**ADDENDUM NO. 4 TO PROJECT NO. 47175**

**CONSTRUCTION, ELEVATOR, HVAC, PLUMBING AND ELECTRICAL WORK  
REPLACE ELEVATORS 1 – 5  
DULLES STATE OFFICE BUILDING  
317 WASHINGTON ST  
WATERTOWN, NY**

August 10, 2023

M-402

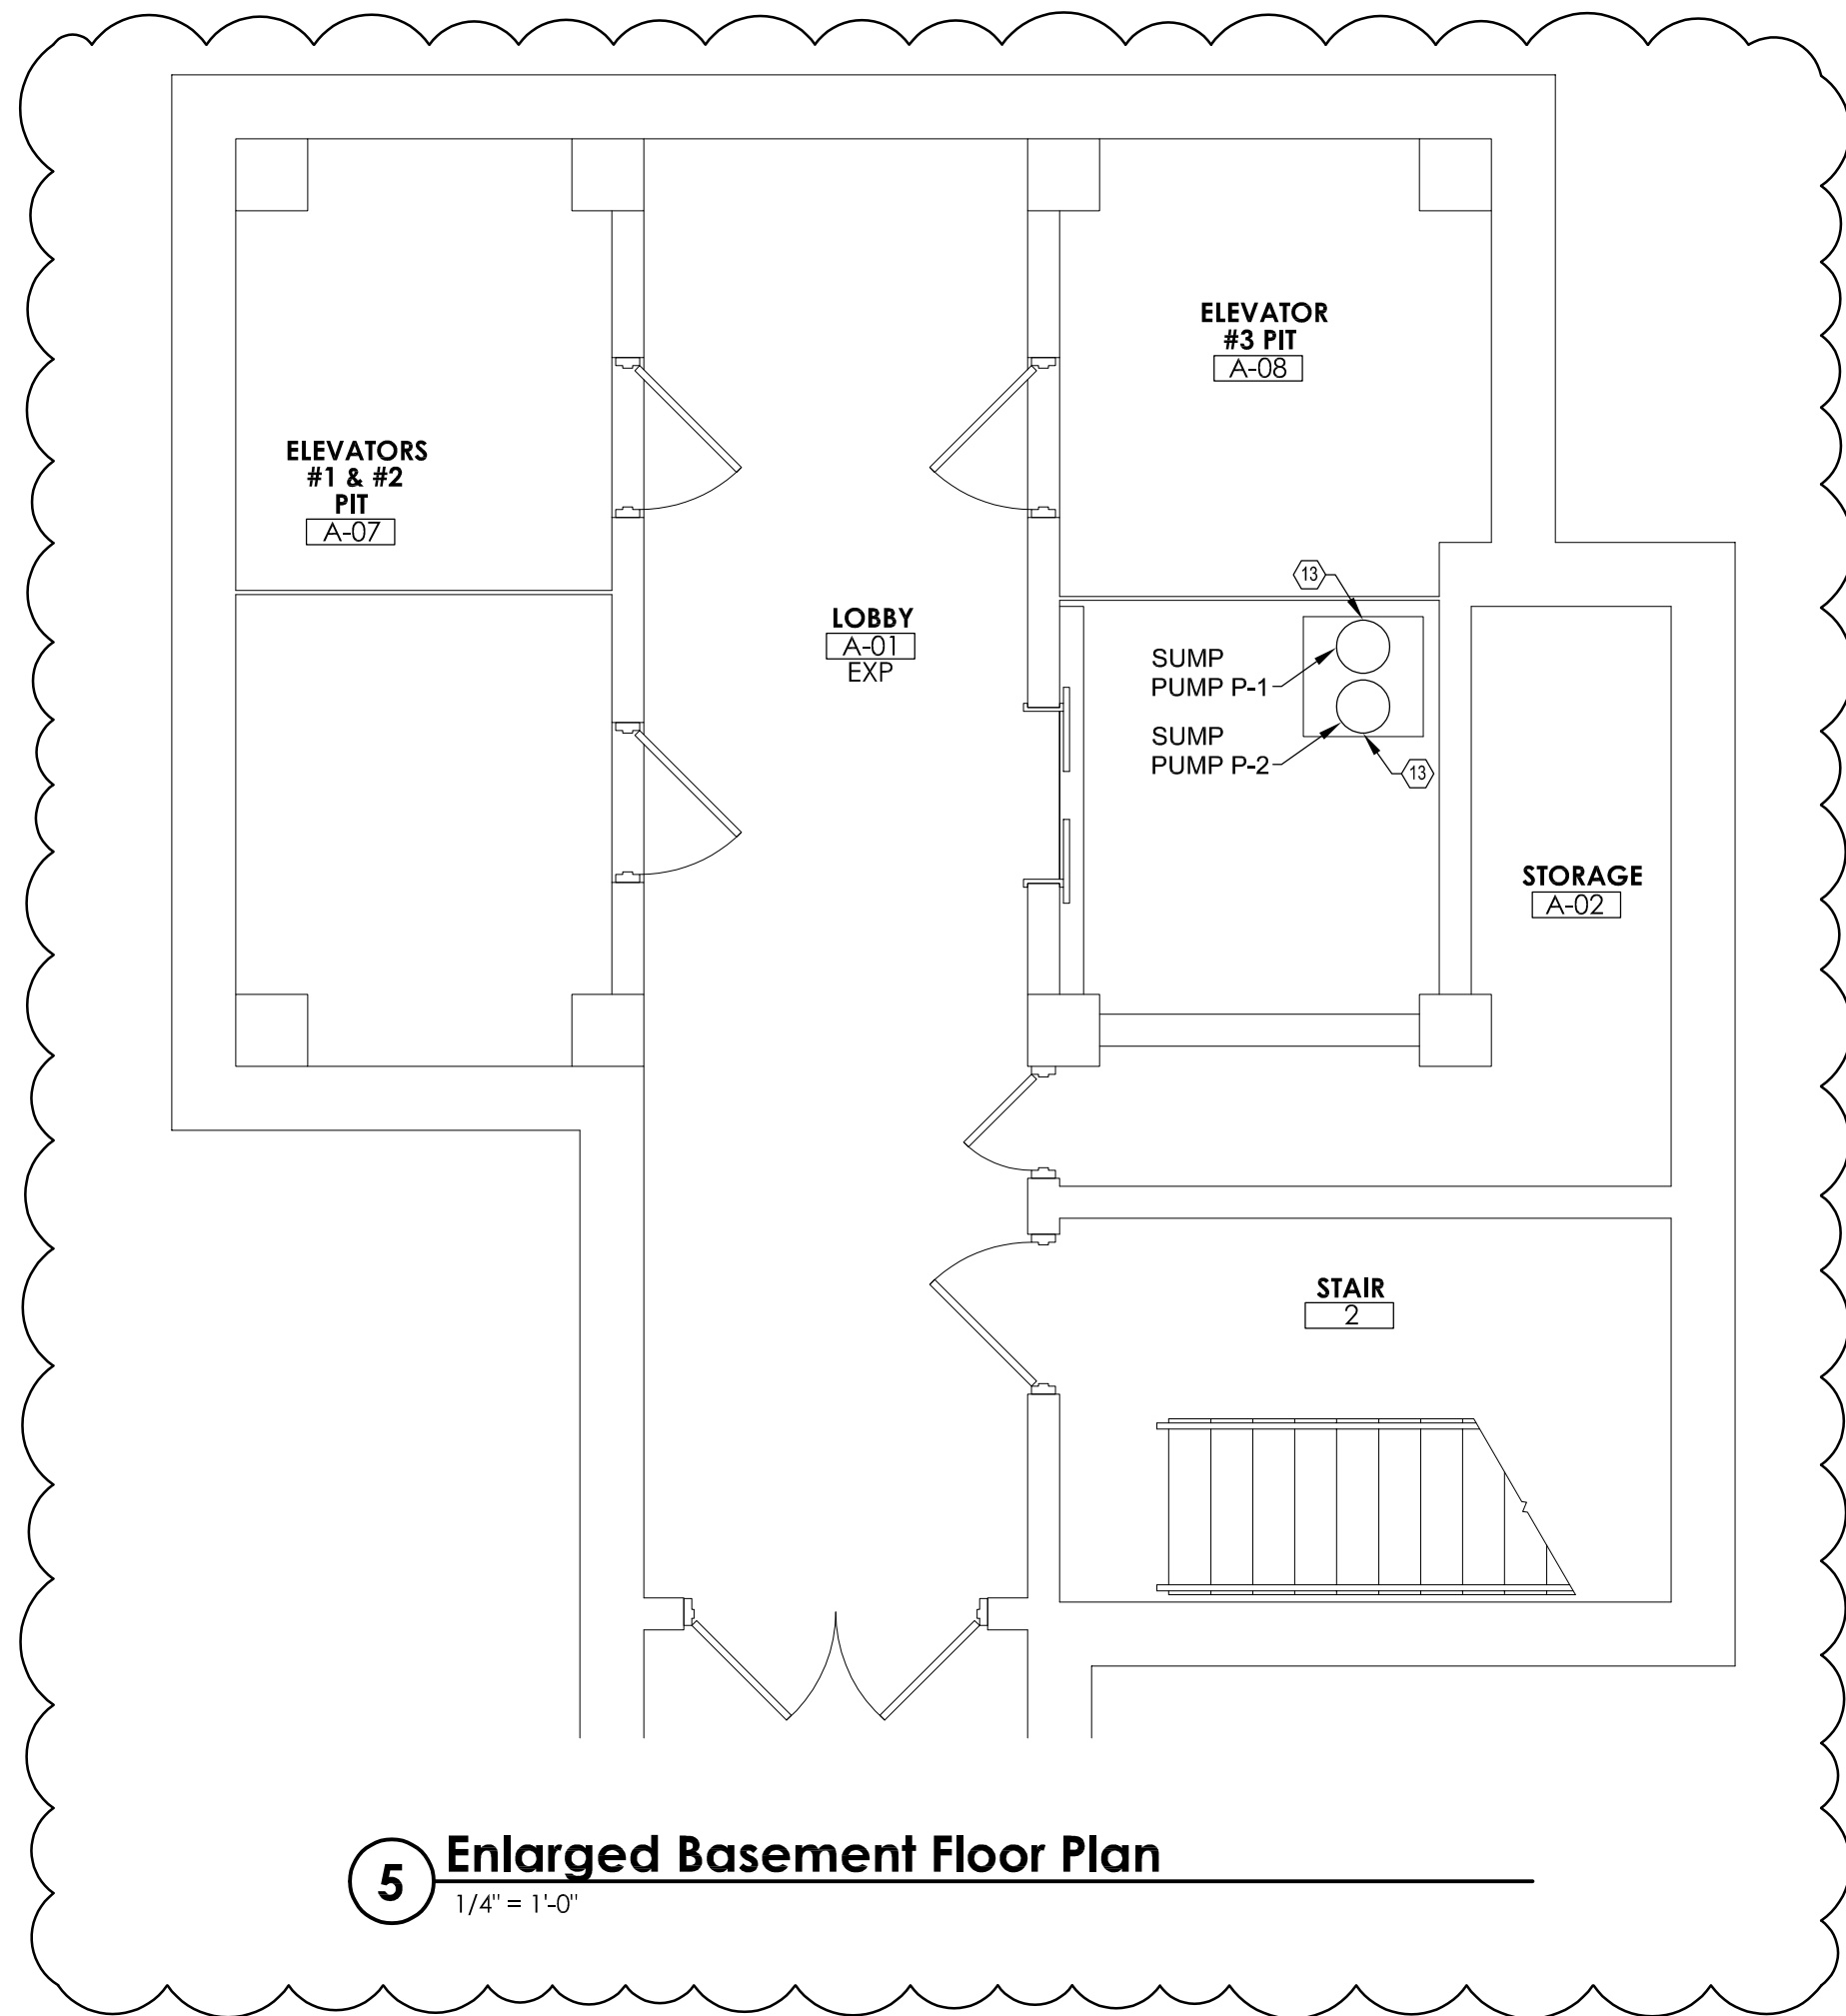
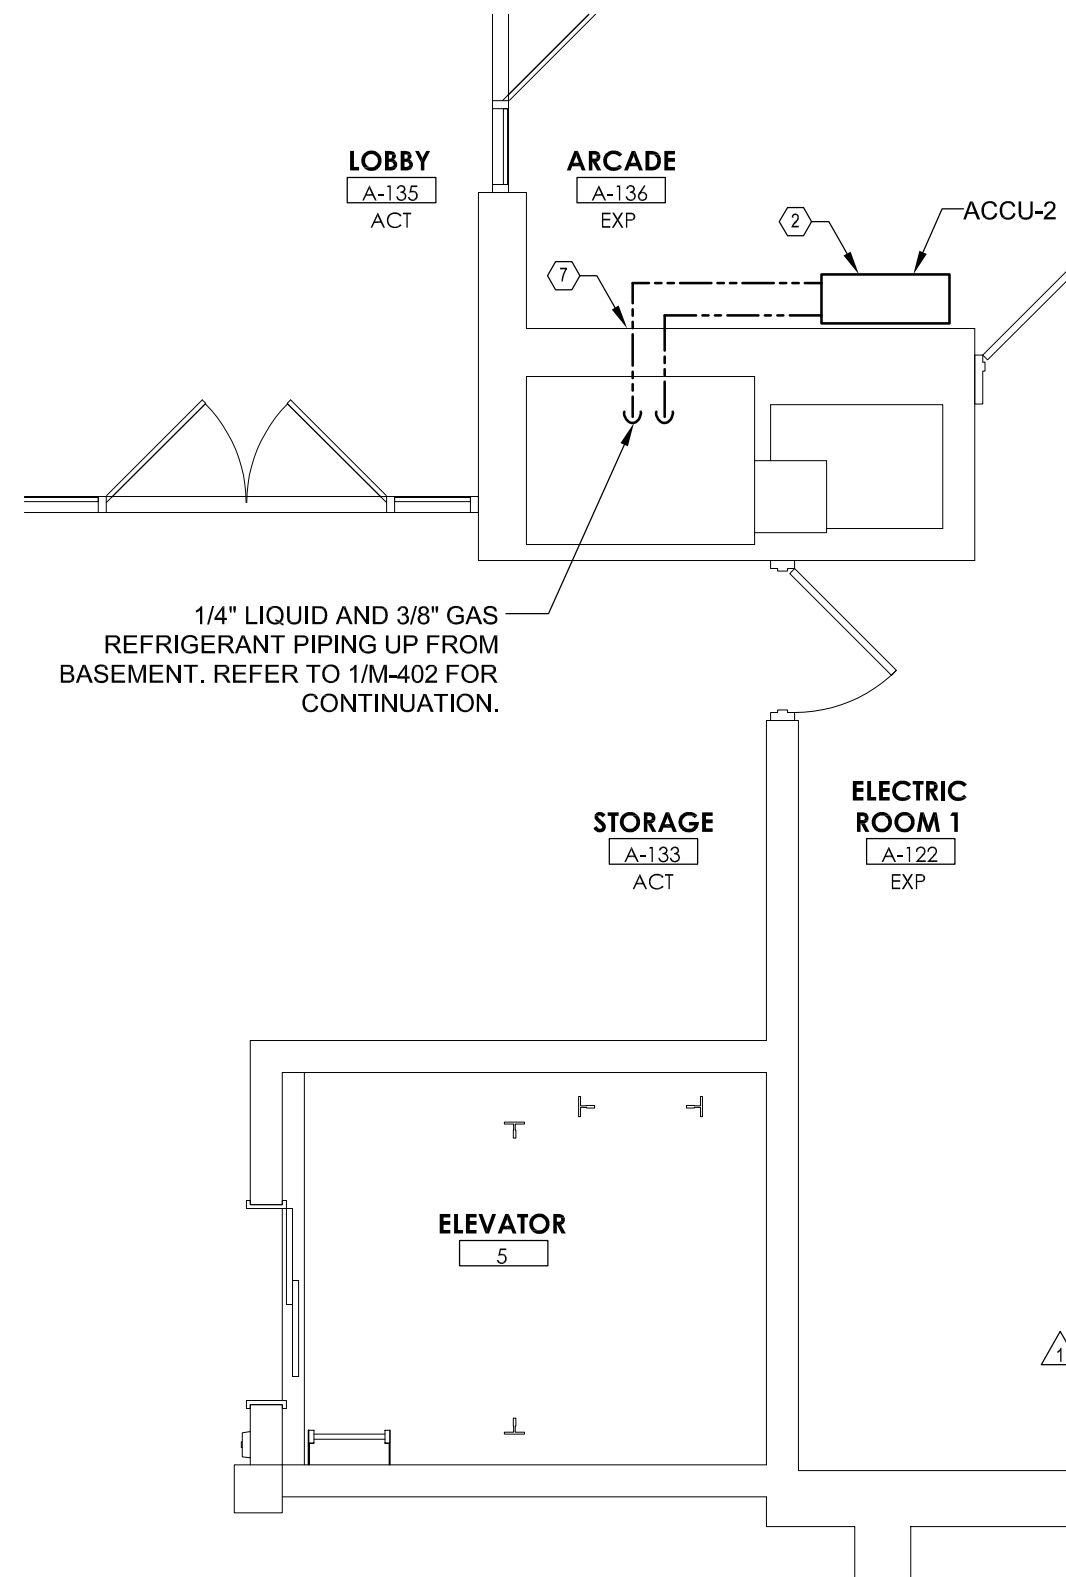
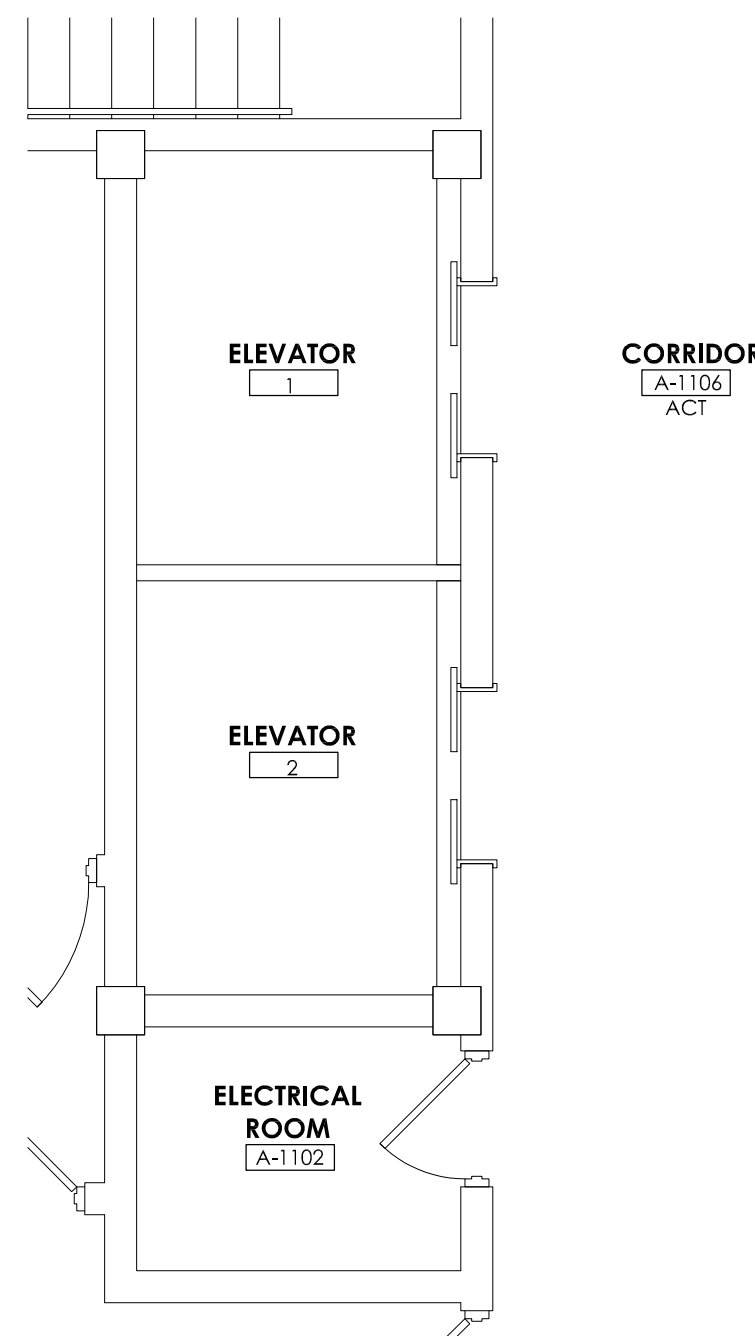
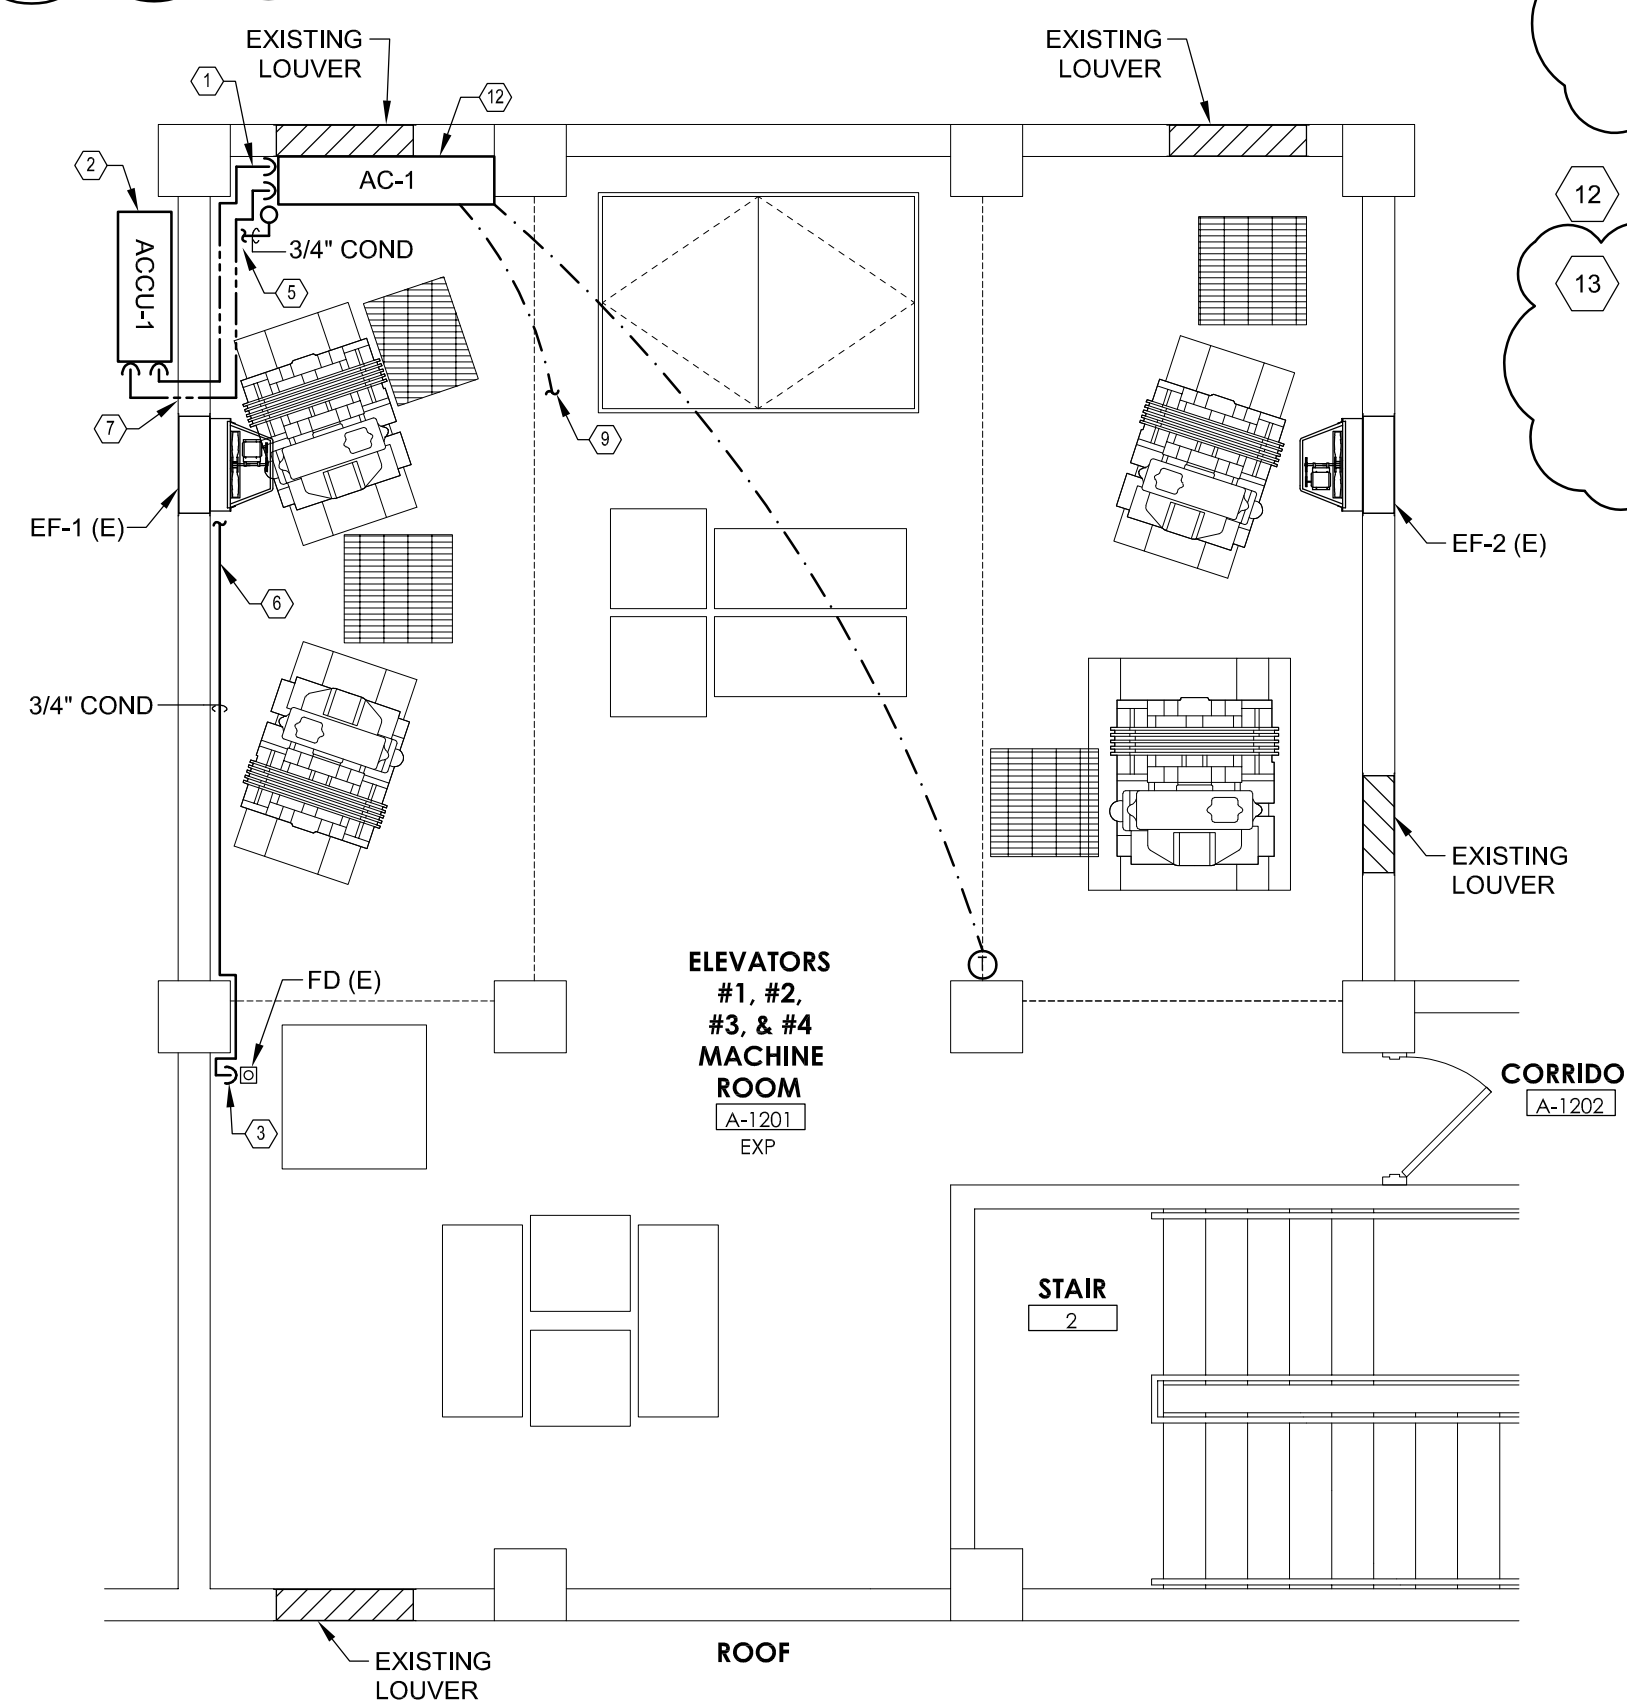
8. Revised Drawings:
  - a. Drawing No. M-001 and M-402, noted “REVISED DRAWING 8/10/2023” accompany this Addendum and supersedes the same numbered originally issued drawing.

- 3/8" LIQUID AND 3/4" GAS REFRIGERANT PIPING TO ACCU-1. MOUNT AC-1 ABOVE EXISTING MOTOR OPERATED DAMPER.
- MOUNT CONDENSING UNIT ON WALL WITH FACTORY OPTION WALL MOUNTING BRACKET. EXTERIOR WALLS ARE ACM. ACCU-1 MOUNTING BRACKET TO BE INSTALLED BY ABATEMENT CONTRACT.

- DRAIN CONDENSATE FROM AC-1 INDIRECTLY TO EXISTING FLOOR DRAIN. REFER TO 2/M-001 FOR INDIRECT DRAIN DETAIL.
- 1/4" LIQUID AND 3/8" GAS REFRIGERANT PIPING UP TO FIRST FLOOR. PROVIDE FIRESTOPPING AT FLOOR PENETRATIONS TO MAINTAIN EXISTING FIRE RATINGS. REFER TO 2/M-402 FOR CONTINUATION.

- CONNECT 1/2" COPPER COND PIPING INTO EXISTING 6" ST PIPING WITH CHECK VALVE.
- INTEGRATE AC-1/ACCU-1 INTO EXISTING SIEMENS BUILDING AUTOMATION SYSTEM (BAS) PANEL LOCATED IN TELECOM A-1110. REFER TO 3/M-402. PROVIDE VISUAL GRAPHIC AND MONITOR THE FOLLOWING POINTS: ON/OFF STATUS, ROOM TEMPERATURE, AND ROOM TEMPERATURE SETPOINT. PROVIDE CONTROL OF THE FOLLOWING POINTS THROUGH THE BUILDING AUTOMATION SYSTEM: ON/OFF, AND SETPOINT. GENERATE BAS ALARM IF ROOM TEMPERATURE DEVIATES FROM SETPOINT BY MORE THAN 5° F. PROVIDE CONTROL WIRING CONNECTIONS TO AC-2/ACCU-2. REFER TO E-CONTRACT DRAWINGS FOR BAS WIRING.

- EXISTING SIEMENS BUILDING AUTOMATION SYSTEM (BAS) PANEL. INTEGRATE SIGNAL FROM AC-1/ACCU-1.
- INTEGRATE AC-2/ACCU-2 INTO EXISTING SIEMENS BUILDING AUTOMATION SYSTEM (BAS). PROVIDE VISUAL GRAPHIC AND MONITOR THE FOLLOWING POINTS: ON/OFF STATUS, ROOM TEMPERATURE, AND ROOM TEMPERATURE SETPOINT. PROVIDE CONTROL OF THE FOLLOWING POINTS THROUGH THE BUILDING AUTOMATION SYSTEM: ON/OFF, AND SETPOINT. GENERATE BAS ALARM IF ROOM TEMPERATURE DEVIATES FROM SETPOINT BY MORE THAN 5° F. PROVIDE CONTROL WIRING CONNECTIONS TO AC-2/ACCU-2. REFER TO E-CONTRACT DRAWINGS FOR BAS WIRING.

- MOUNT AC-1 ABOVE EXISTING LOUVER, APPROXIMATELY 6'-8" AFF.
- INTEGRATE SUMP PUMP INTO EXISTING SIEMENS BUILDING AUTOMATION SYSTEM (BAS). PROVIDE VISUAL GRAPHIC AND MONITOR THE FOLLOWING POINTS: ON/OFF STATUS. GENERATE BAS ALARM IF SUMP PUMP IS ON. PROVIDE CONTROL WIRING CONNECTIONS TO SUMP PUMPS. REFER TO E-CONTRACT FOR BAS WIRING. REFER TO P-CONTRACT FOR SUMP PUMP SCHEDULE AND DETAILS.
